SUBJECT: Approved Equipment Frequency Allocation Papers for the AeroVironment Data and Video Links, ASC 2004-23 and ASC 2004-24.

MILITARY COMMUNICATIONS ELECTRONICS BOARD (MCEB) EQUIPMENT FREQUENCY ALLOCATION GUIDANCE				
Military Department Air Force Navy Army	Equipment AeroVironment Video Link	Stage 4 - Operational		
Section 1: ENCLOSURES				
Enclosure Number 1	Description J/F 12/8252	Dated 13 September 2004		
Section 2: OPERATING CHARACTERISTICS FOR WHICH SUPPORT IS CERTIFIED				
Frequency (MHz) 1755-1850	Emission 14M8F9W	Power (Mean) 1.5 W	Type of Service Aeronautical Mobile	Operating Location US&P
Section 3: MCEB GUIDANCE				
<p>1. The enclosed application is approved for operational systems at the above locations subject to the guidance provided in the following paragraphs.</p> <p>2. For the intended operation in the Aeronautical Mobile service, the subject equipment is in accordance with the ITU and US Tables of Frequency Allocation.</p> <p>3. Based on the information provided,</p> <p style="margin-left: 40px;">a. The transmitter does not comply with NTIA Manual, Sections 5.2.1, requirements for frequency tolerance.</p> <p style="margin-left: 40px;">b. The transmitter compl

PICTORIAL LINE DIAGRAM

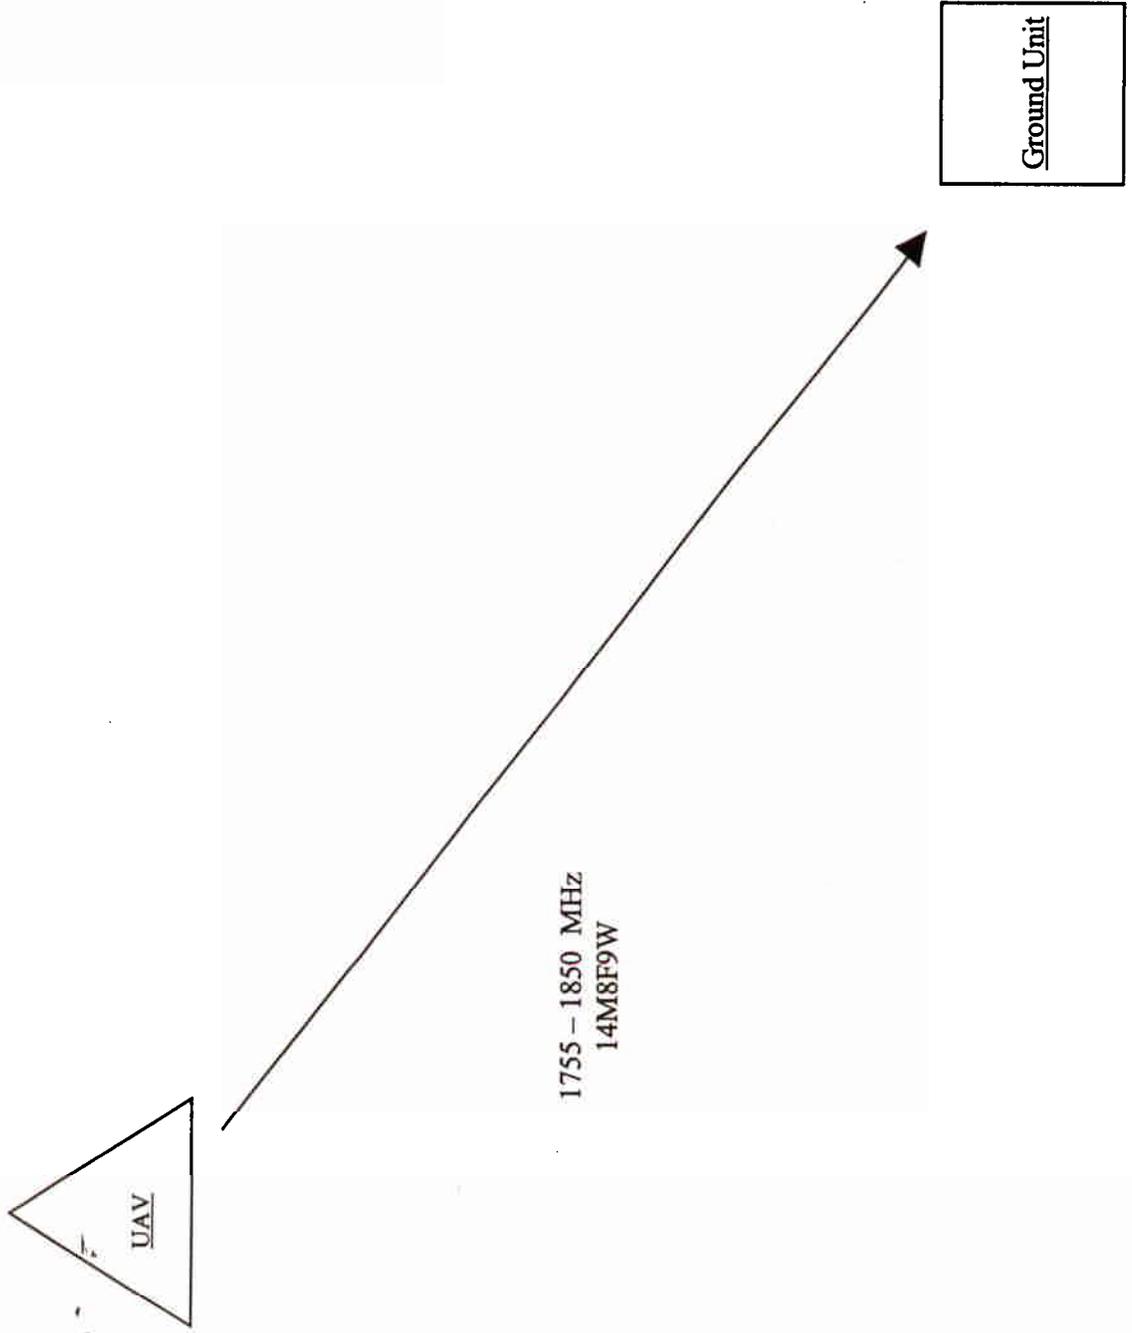
- b. The 1755-1850 MHz band is a heavily used band and use of this system within this band will require extensive coordination and/or EMC analysis to prevent any potential mutual interference to or from other systems (for each location).

- c. Be aware that this system does not comply with frequency tolerance as specified in Table 5.2.1 of the NTIA manual and therefore, if interference occurs, mitigating interference normally rests with the station in non-conformance.

PICTORIAL LINE DIAGRAM

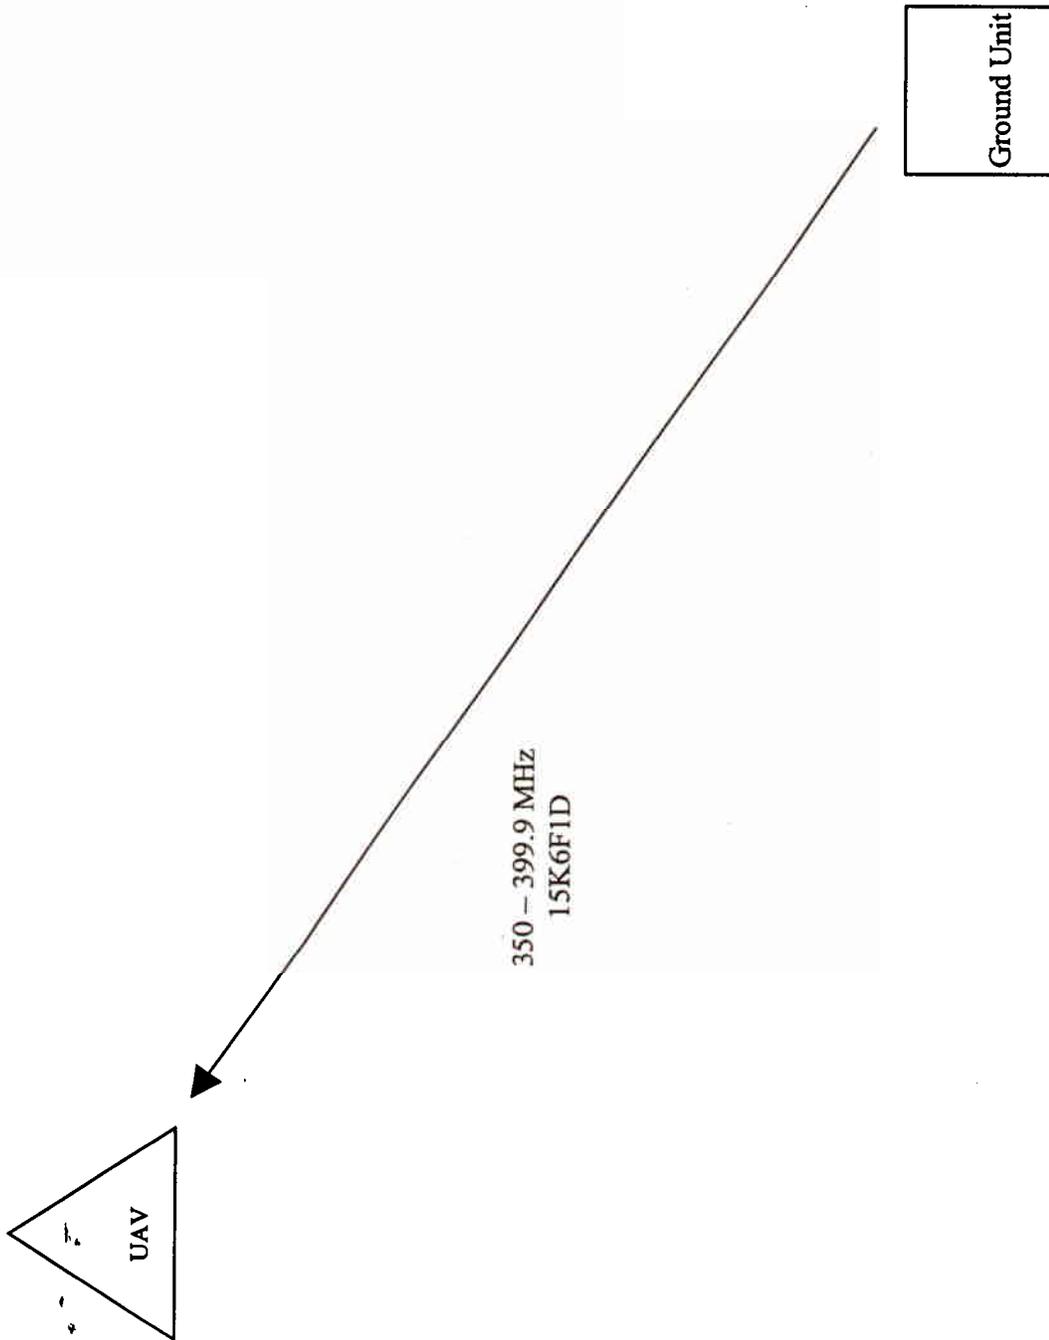
2. For the AeroVironment Data Link, please note frequency assignment requests must be submitted and specific frequencies identified prior to selection of factory fixed frequencies.

5. Use of this system must be in accordance with the channeling plans for the 225-399.9 MHz band. Assignments that do not fit the wideband channels in the 380-399.9 MHz band may be very difficult to obtain. Per SECDEF Memo, 1 Aug 2001, Subj: Policy for Land Mobile Radio, the band 380-399.9 MHz will be heavily used by Land Mobile Radio (LMR) systems in the future. The Program Office might consider moving the uplink of this system to operate in the 225-380 MHz band at the earliest opportunity to ensure future frequency assignments availability. The 225-380 MHz band is heavily used by various space, ground, airborne and sea communication systems; however, there are more channels available in this band than in the 380-399.9 MHz bands.
